STATE OF NORTH CAROLINA  
DEPARTMENT OF TRANSPORTATION

November 04, 2020

Subject: **Request for Modification to Individual Section 404 and Section 401 Water Quality Certification** for the Winston-Salem Northern Beltway from US 52 to US 311 (New Walkertown Road), Forsyth County. Federal Aid Project No. NHP-0074(213), TIP Nos. U-2579D, E& F. Division 9.

**UT to Mill Creek and Mill Creek  
On-site Stream Mitigation Feasibility Report for  
Winston-Salem Northern Beltway  
Forsyth County, North Carolina**

**Figure 7**

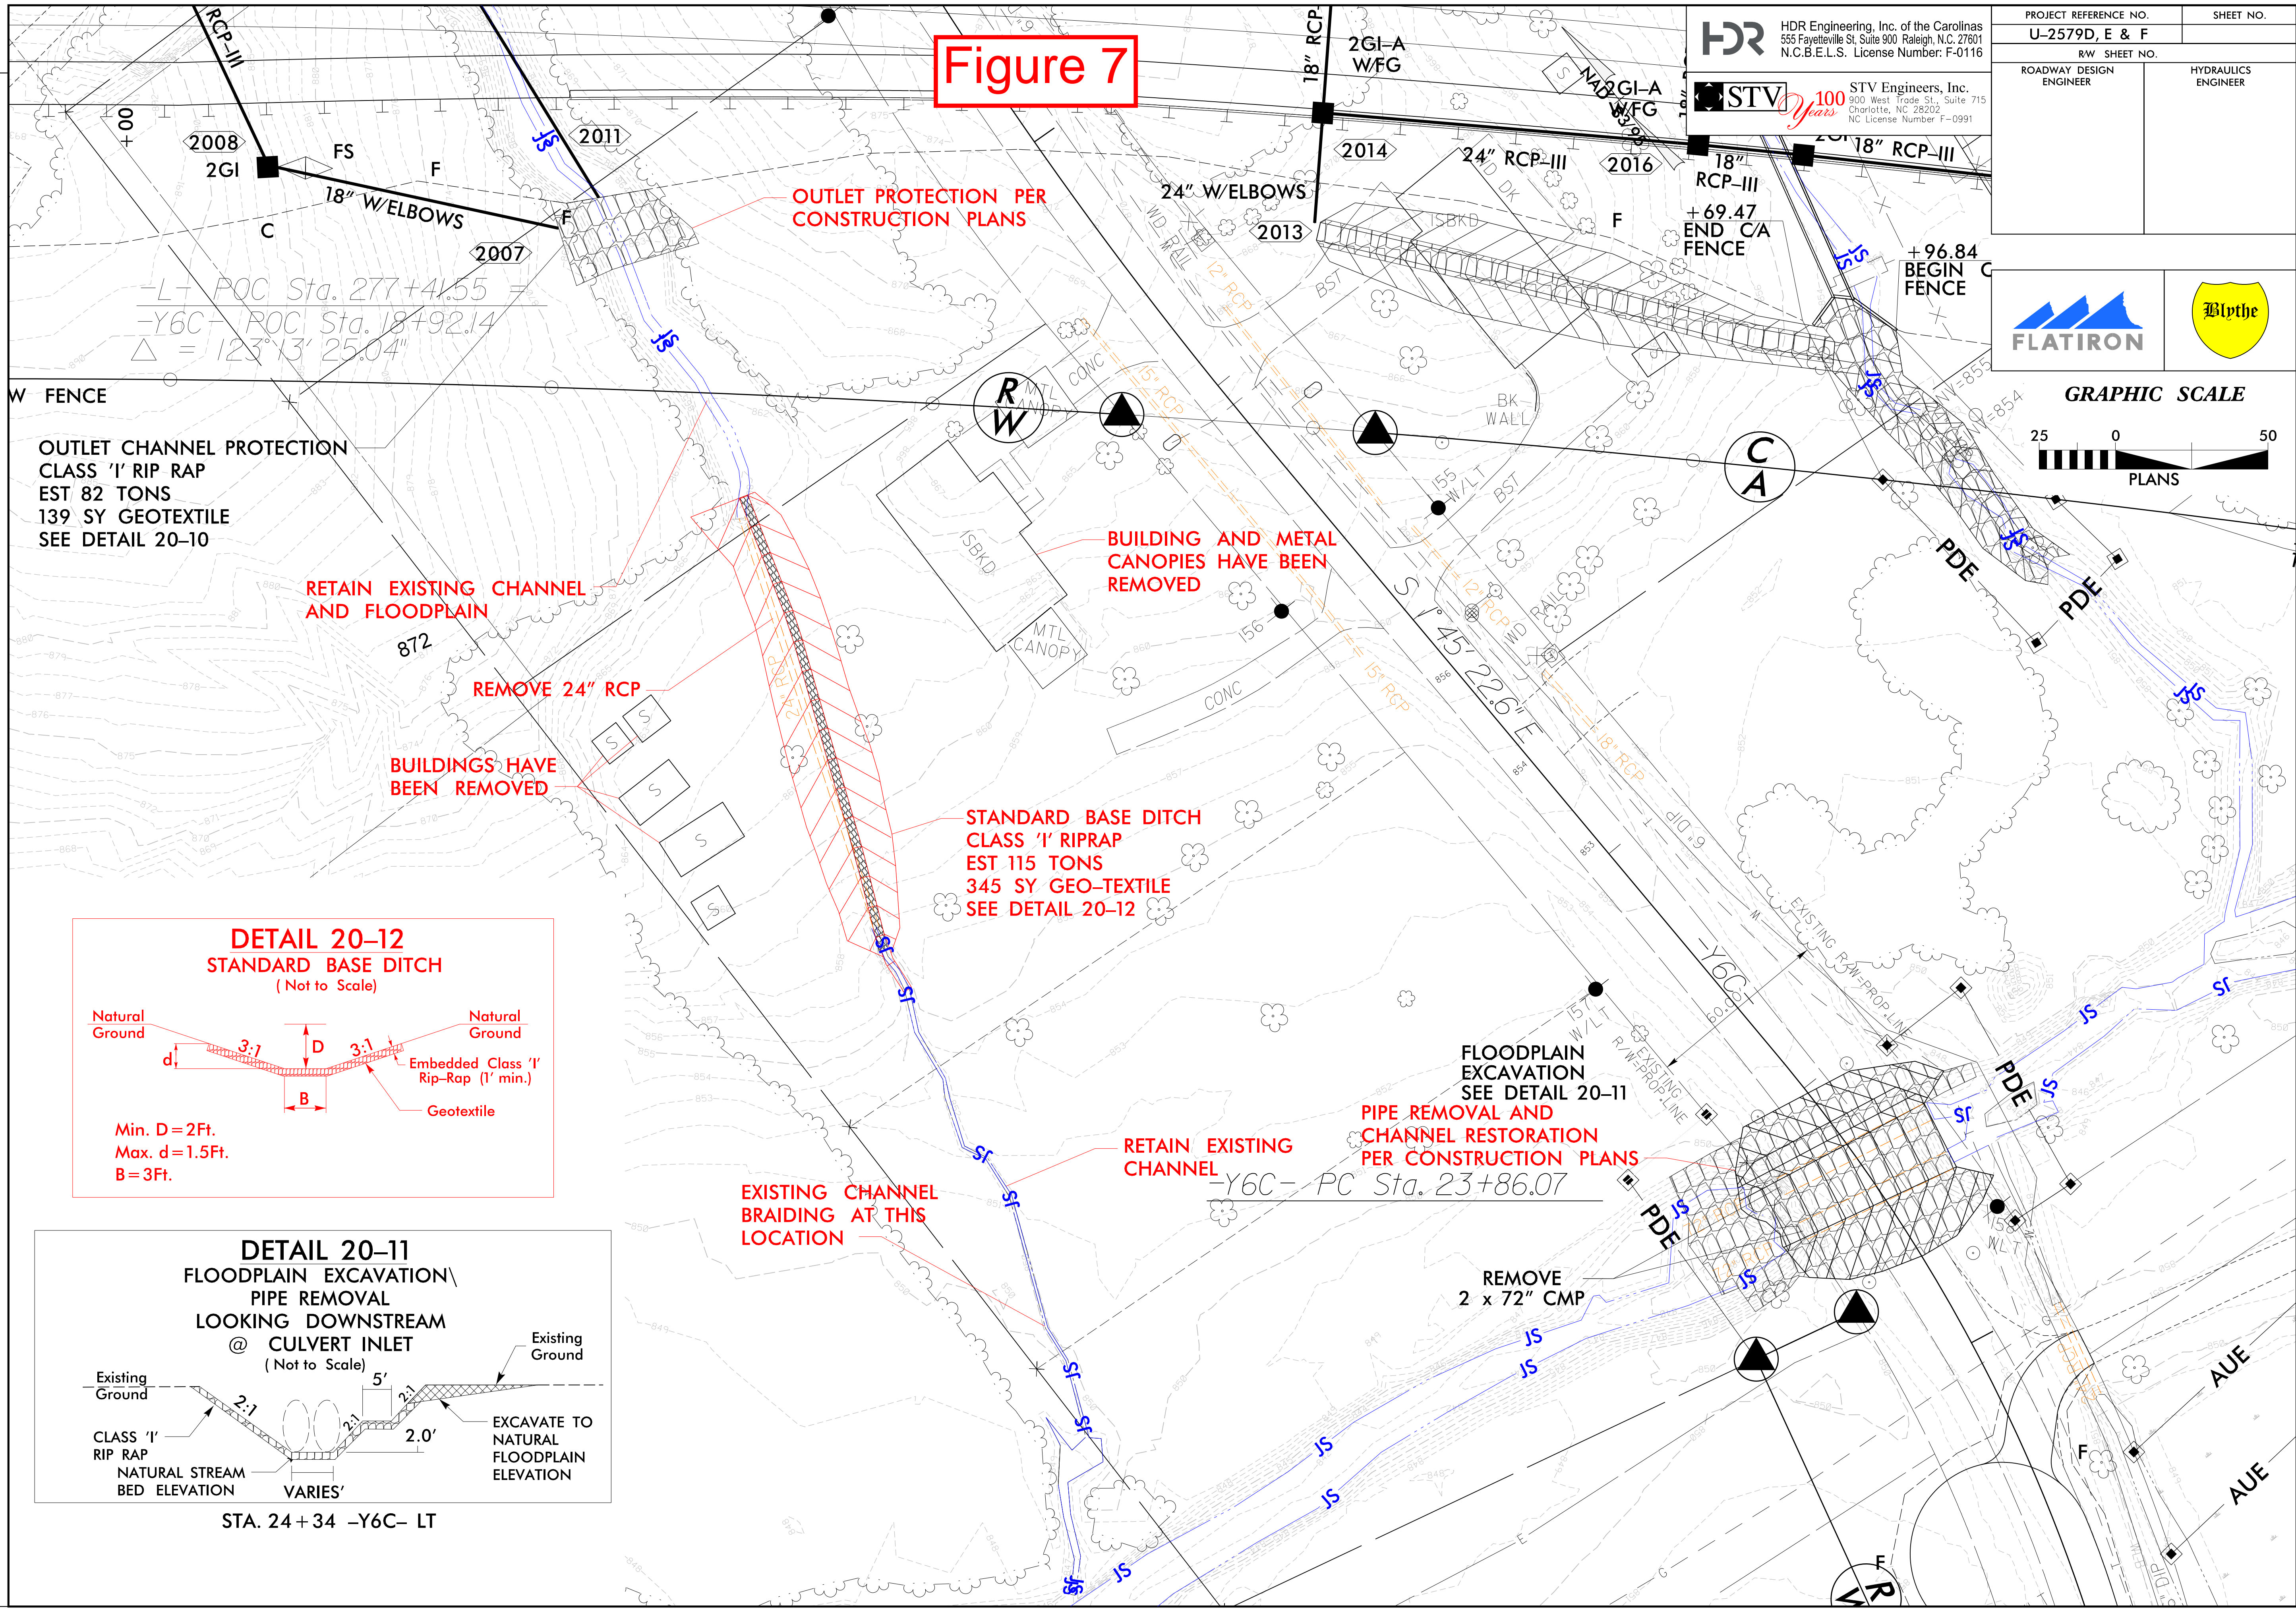
- Option 1b incorporates restoration, enhancement, and preservation of UT to Mill Creek. This option attempts to strike a balance between the costs of full restoration and obtaining mitigation credits. See Figures 4 thru 6.
- Option 1c, is based on removing 141 linear feet of existing 24” pipe and replacing it with a standard base ditch with embedded riprap for stability. This option does not propose mitigation credits for this work. Instead, it avoids a potential issue with the existing pipe in the future by removing it prior to access being removed or restricted. See Figures 7 and 8.

At the locations noted on Figures 4 and 7, the existing channel braids with some channel flow accessing the floodplain of Mill Creek. If we were to take this channel offline we would face challenges with grade change and tying a new channel into Mill Creek in a stable fashion.

Based on the above description of options regarding mitigation at the UT to Mill Creek and Mill Creek at Phelps Drive, NCDOT has determined the best path forward as Option 1c which is to remove the pipe on the UT to Mill Creek and stabilize the area and 2b which is removing the pipe on Mill Creek and proceeding with the permitted plans for stabilizing the channel. The decision to move in this direction was based on a number of factors such as cost of construction when weighed against the potential mitigation credits, long term monitoring and maintenance of the site, and utility encroachments. The overall benefit of doing full restoration would not provide significant ecological uplift on either reach and could introduce instability of either reach following construction.

PROJECT REFERENCE NO. <b>U-2579D, E &amp; F</b>	SHEET NO. <b>24</b>
RW SHEET NO.	
ROADWAY DESIGN ENGINEER	HYDRAULICS ENGINEER
<b>DOCUMENT NOT CONSIDERED FINAL UNLESS ALL SIGNATURES COMPLETED</b>

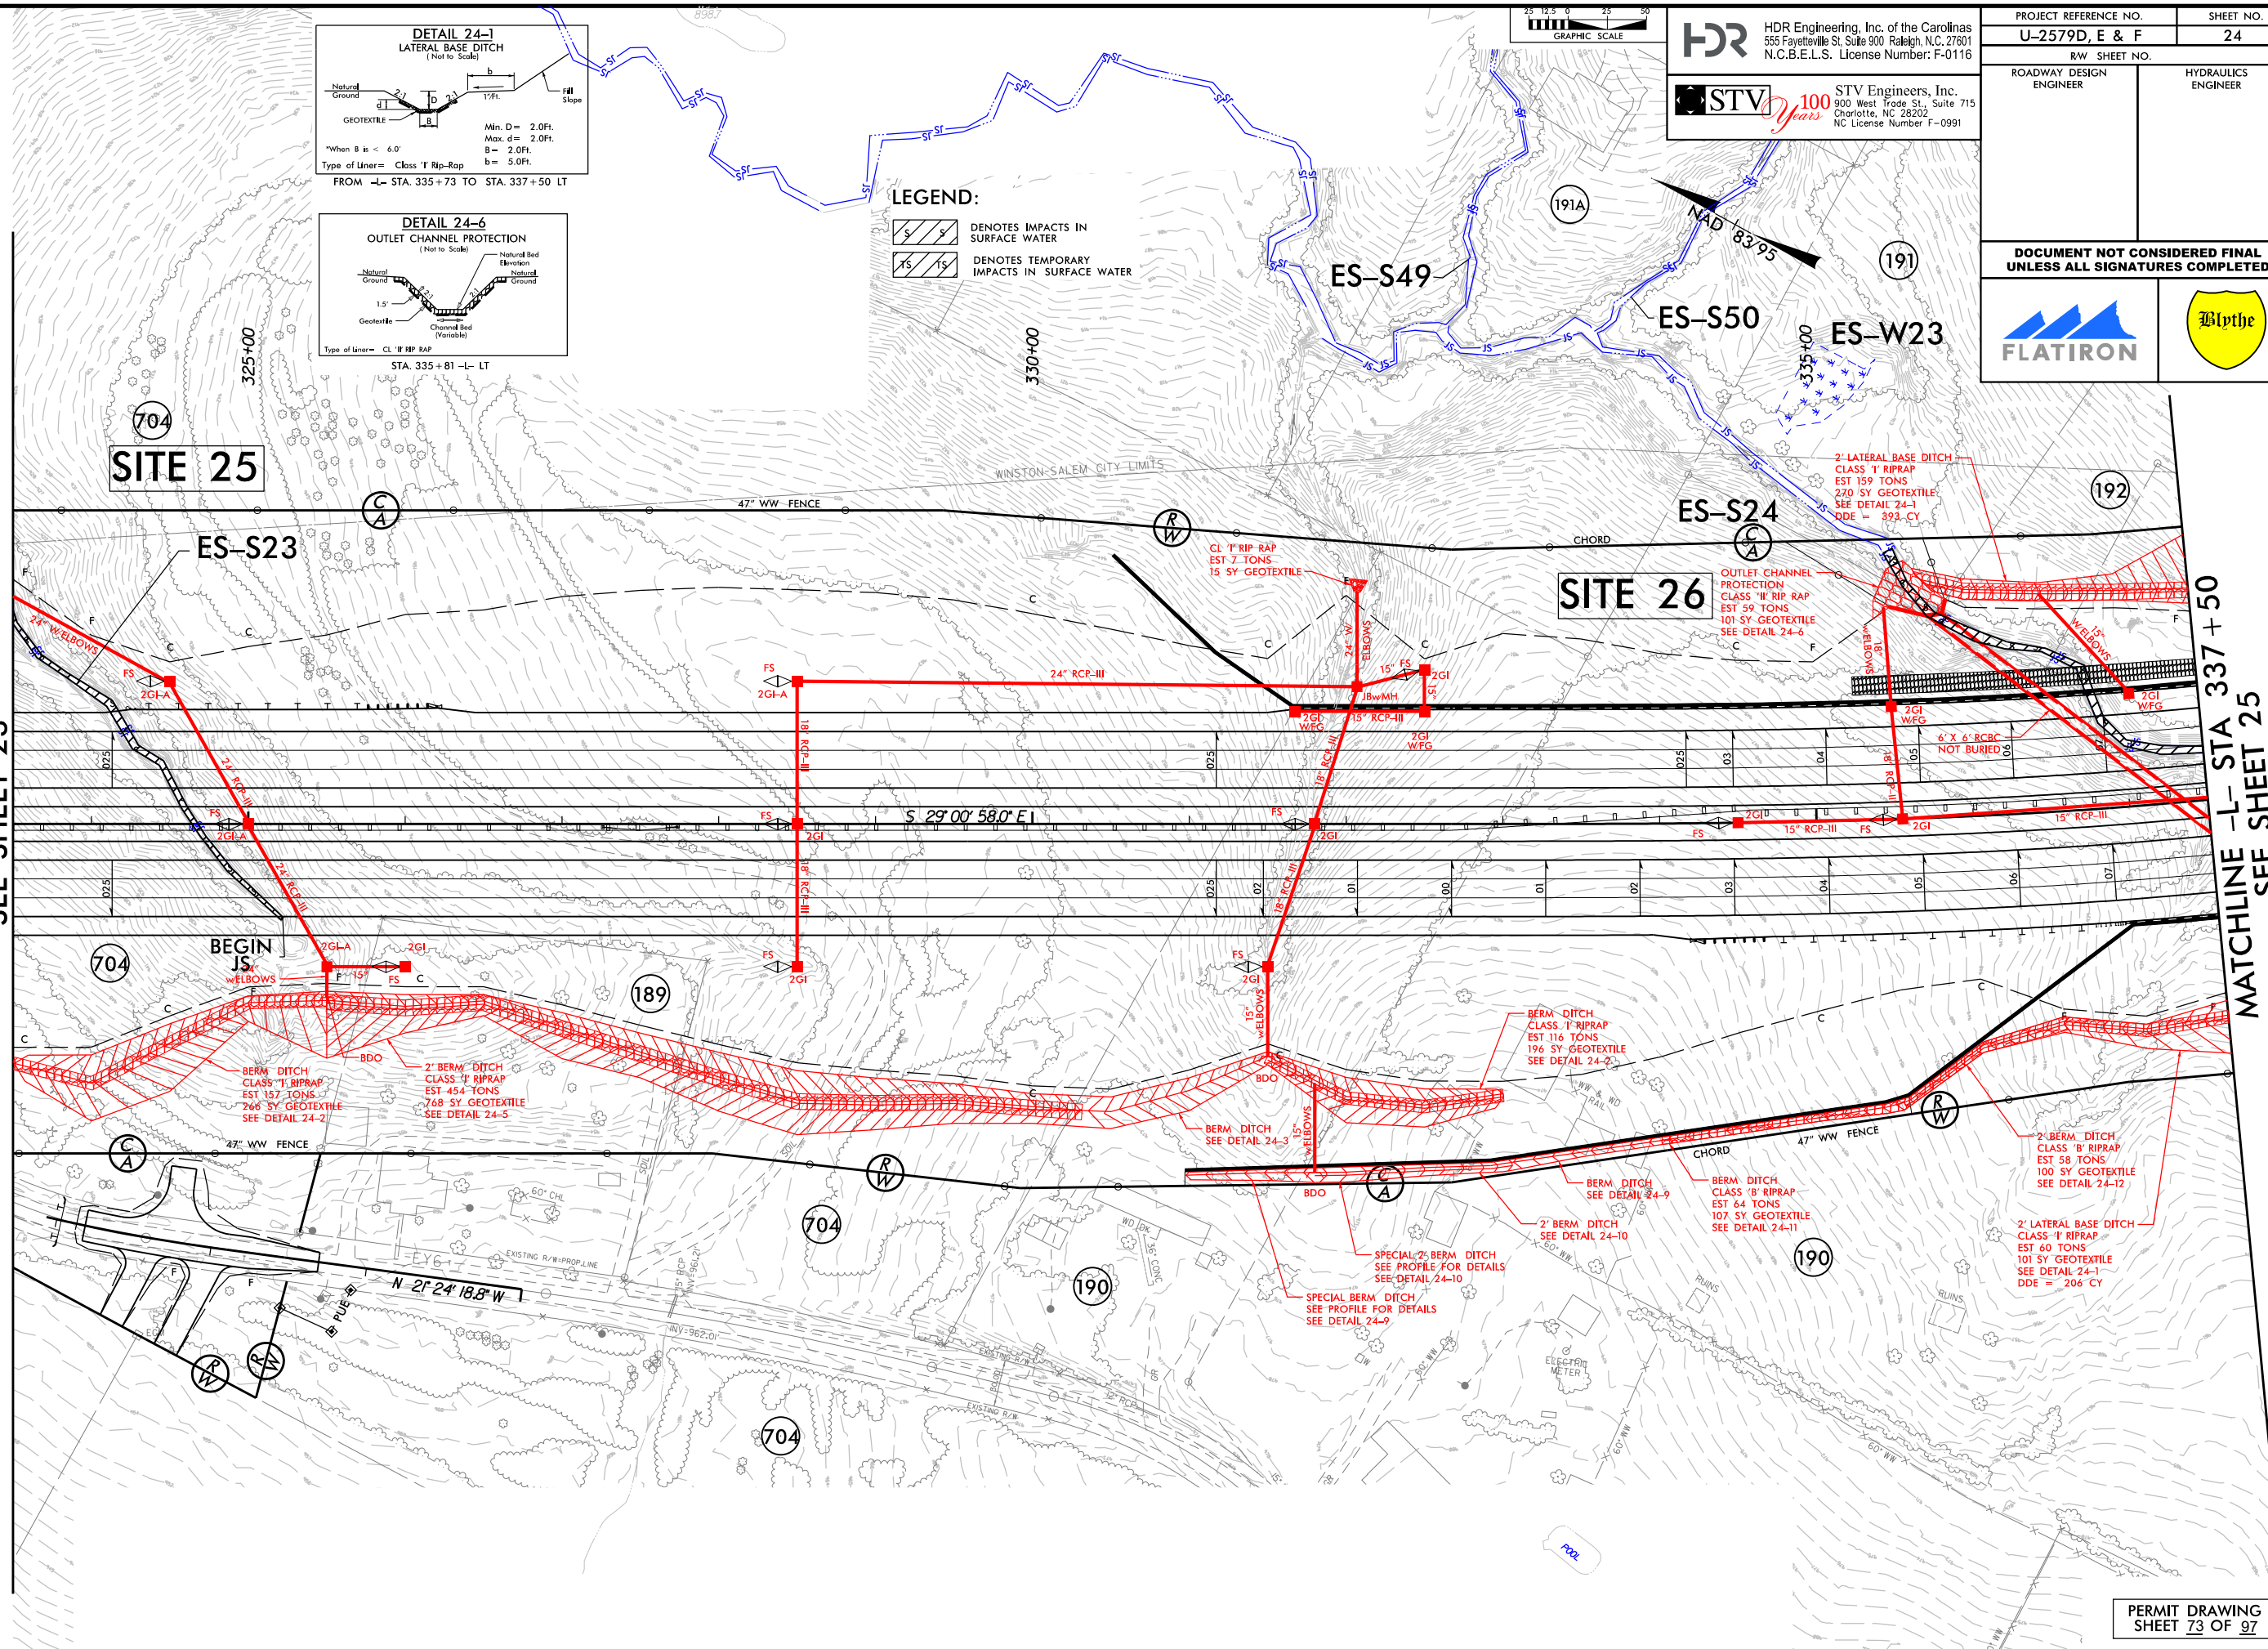
Site 26 (Roadway Plan Sheets 24/25): Site 26 impacts have not changed from the modification dated January 2020; however, the design has changed due to the noise walls. A ditch is required along the toe of fill that will tie to the existing bank stabilization at the inlet of ES-S24. The updated plan sheets are attached.
